**HISTORIC PRESERVATION REVIEW BOARD
STAFF REPORT AND RECOMMENDATION**

Landmark/District: **Georgetown Historic District** (x) Agenda
Address: **1513 Wisconsin Avenue NW**

Meeting Date: **May 28, 2015**
Case Number: **15-275** (x) Addition

Staff Reviewer: **Tim Dennée** (x) Concept

1513 and 1511 Wisconsin Avenue NW

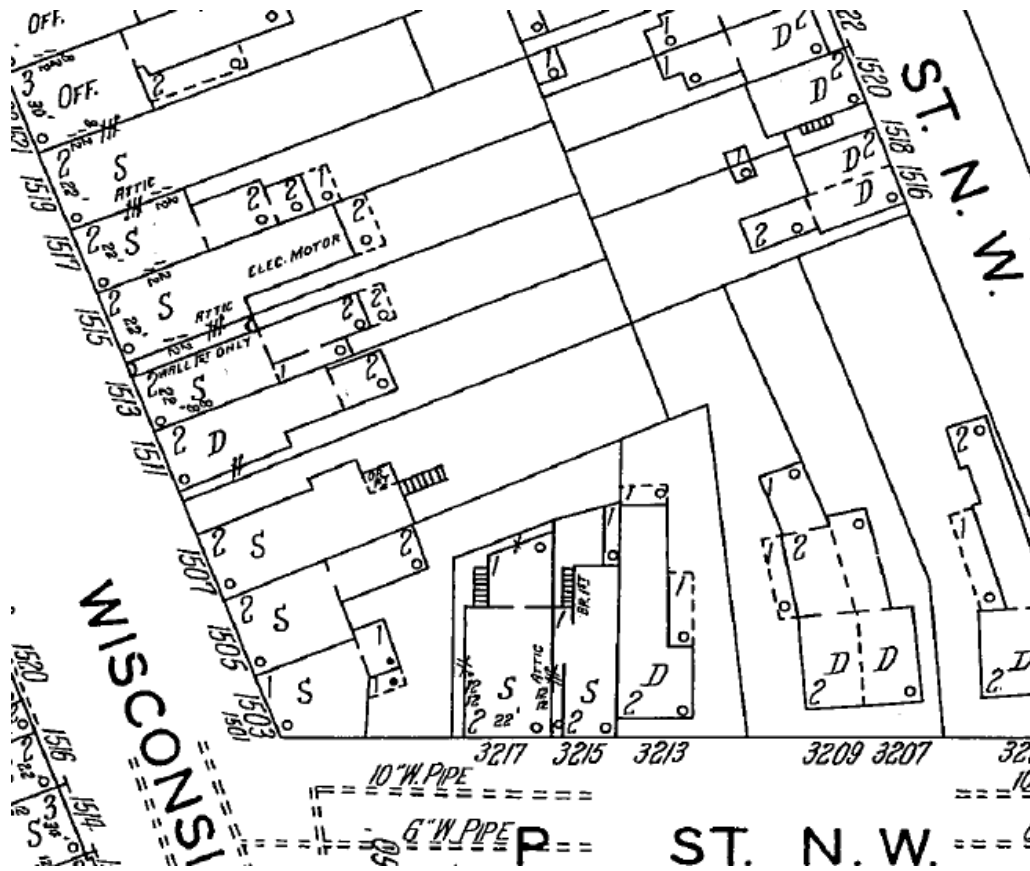
The applicant, property owner 1513 Wisconsin Ave LLC (with architect Stephen DuPont, Jr.), requests the Board’s review of a concept to construct a roof addition and a three-level rear addition to this two-story brick 1880s building. Like many of the commercial buildings on upper Wisconsin, this one was constructed as a dwelling, and its ground floor was repurposed later, in this case, during the first quarter of the twentieth century.
